File: 4814.00

November 15, 2018

Re: Rural Municipality of Gimli- Gimli Wastewater Treatment Plant – Minor Notice of Alteration Approval – Environment Act Licence No. 2587

Figure 2: Temporary Removal of the Emergency Detention Lagoon Fence between Points A and E, and A and D, and Temporary Relocation of the Fence from Points C to F.

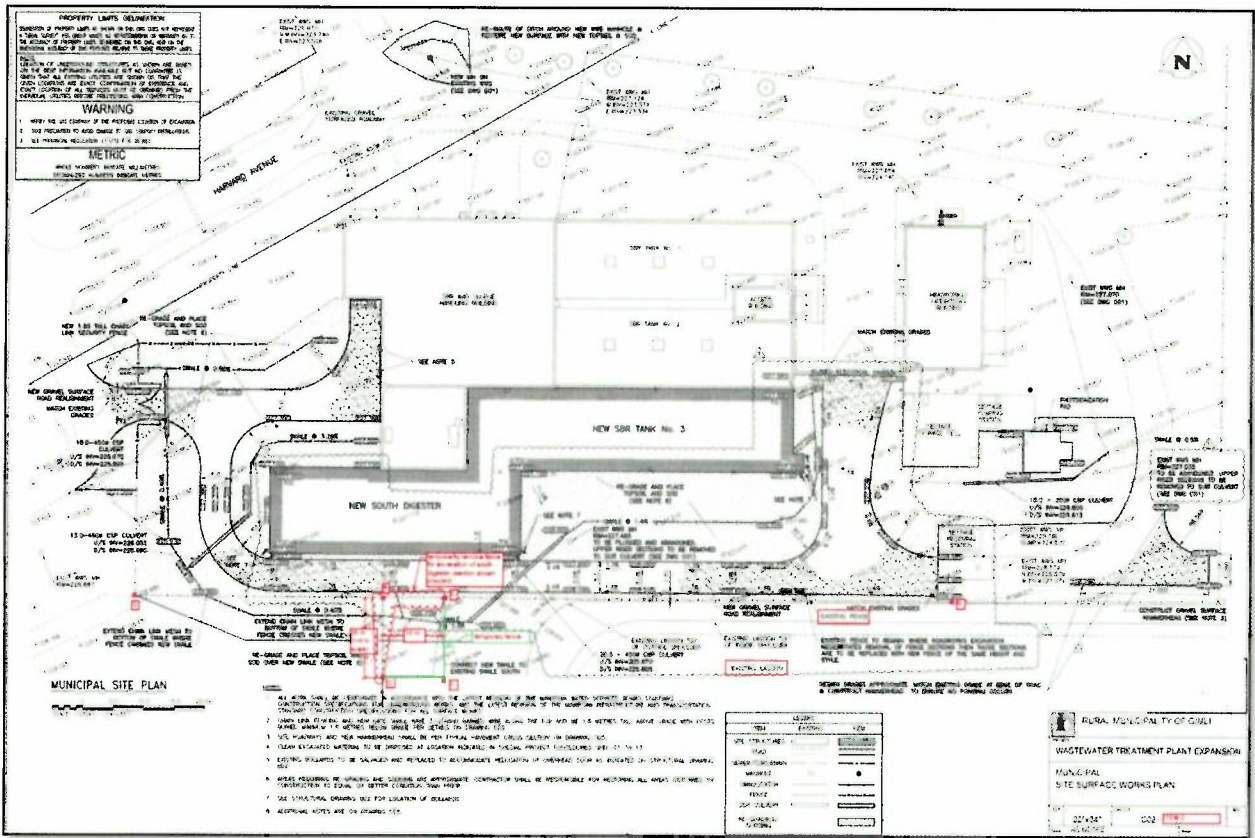
The intent of the NoA is to temporarily remove a portion of the overflow detention lagoon fence and to temporarily relocate the fence for the construction of the adjacent roadway and a new digester.

1. The Licencee shall notify the designated Environment Officer prior to beginning of the proposed fence removal work and after permanently reinstalling the portion of the fence to its original location.
2. The Licencee shall temporarily remove the portion of the fence and permanently reinstall the portion of the fence to its original location in accordance with Schedule "A" of this approval.

3. The Licencee shall permanently reinstall the portion of the fence to its original location by August 30, 2019.
4. The Licencee shall submit an emergency operational plan by November 23, 2018, for review and approval of the Director of Environmental Approvals Branch, in order to operate the existing overflow detention lagoon in accordance with the approved emergency operational plan until such a time that the affected north-west corner of the existing overflow detention lagoon has been repaired in accordance with Clause 8 of this approval.
